**Town of Essex, Vermont**  
**Application for Zoning Permit**  
(Building Permit)

Application Date 1/1/25  
Permit Number 2025-185

Property Address: 67 Brigham Hill Lane, Essex

**TOWN OF ESSEX, VERMONT  
APPLICATION FOR CURB CUT / UTILITY PERMIT**

# Existing curb cut

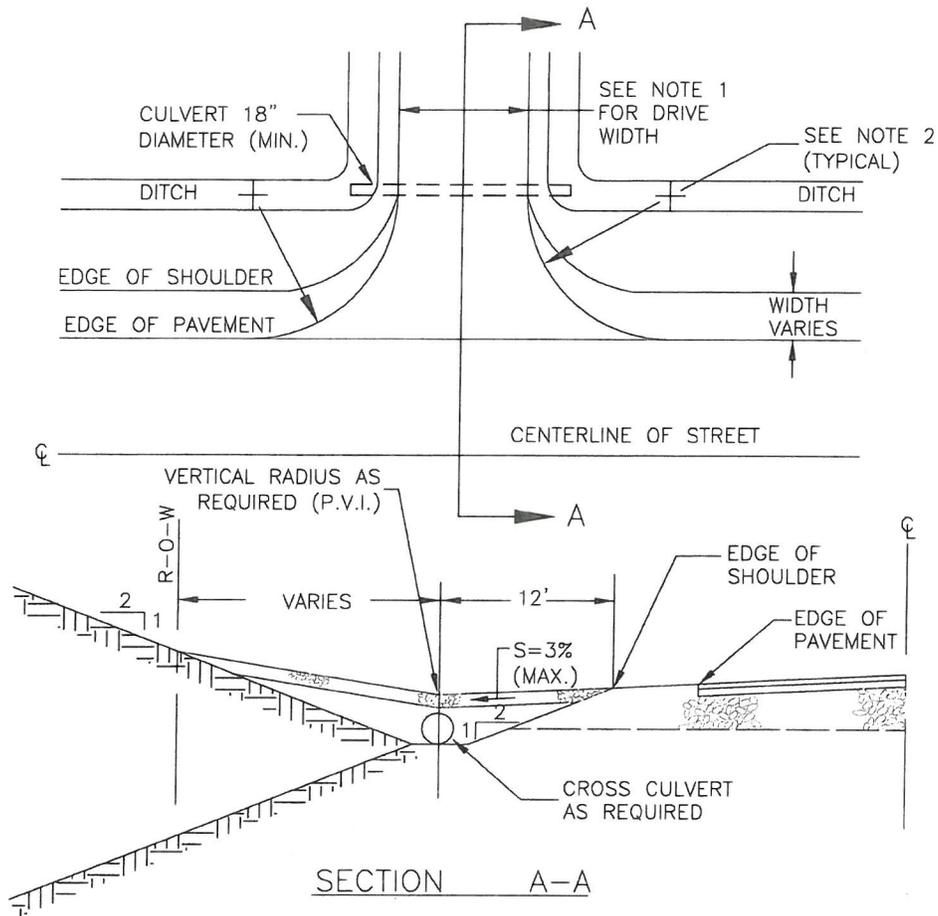
- THE DITCH TO THE EXISTING CROSS CULVERT IS TO BE REESTABLISHED (SEE GRASS LINED SWALE DETAIL.)
- "HUMP" AREA IS TO BE CLEARED OF TREES AND LOWERED TO PROVIDE 250 FT OF SIGHT DISTANCE THIS MAY REQUIRE LEDGE REMOVAL
- APRON IS TO BE CONSTRUCTED AS PER DETAIL A-10 AND GRADED AS PER DETAIL A-9.
- A DRIVEWAY CULVERT IS NOT NECESSARY.
- INSPECTION IS REQUIRED AT SUBGRADE EXCAVATION AND AT FINAL.

1. Culvert must be HIGH DENSITY POLYETHYLENE (HDPE) PIPE
2. Culvert will be purchased by the Applicant  
Culvert will be purchased and installed by the applicant. The Town of Essex Department of Public Works will inspect.
- 3.
